Release Notes: xD3 Firmware V1.3

The xD3 module firmware update applies to all EXS models:

EXS-1 Mk2, EXS-2 Mk2, EXS-3, EXS-3CY, EXS-5.

New Feature: Delete Kit

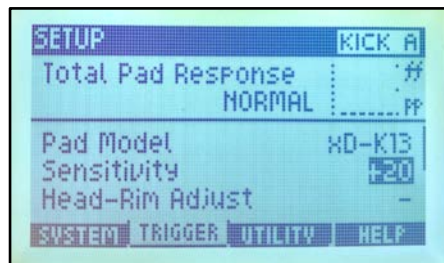
A **Delete Kit** function has been added to the SETUP | UTILITY menu.

The Delete Kit screen displays the list of installed kits excluding the five factory preset kits.

A listed kit can be selected and deleted from the module.

The currently loaded kit cannot be deleted.

Change: Trigger Sensitivity Setting Range

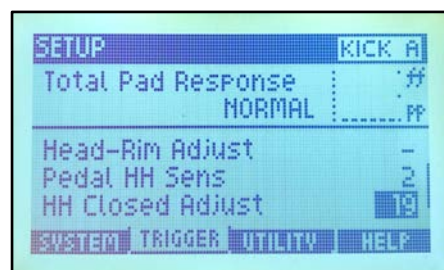
In the SETUP | TRIGGER menu, the range of the **Sensitivity** setting has been modified.

The new range for all pads is -10 to +20.

The extended value range assists EXS-5 users in setting the sensitivity for the xD-K13 and xD-P13M pads.
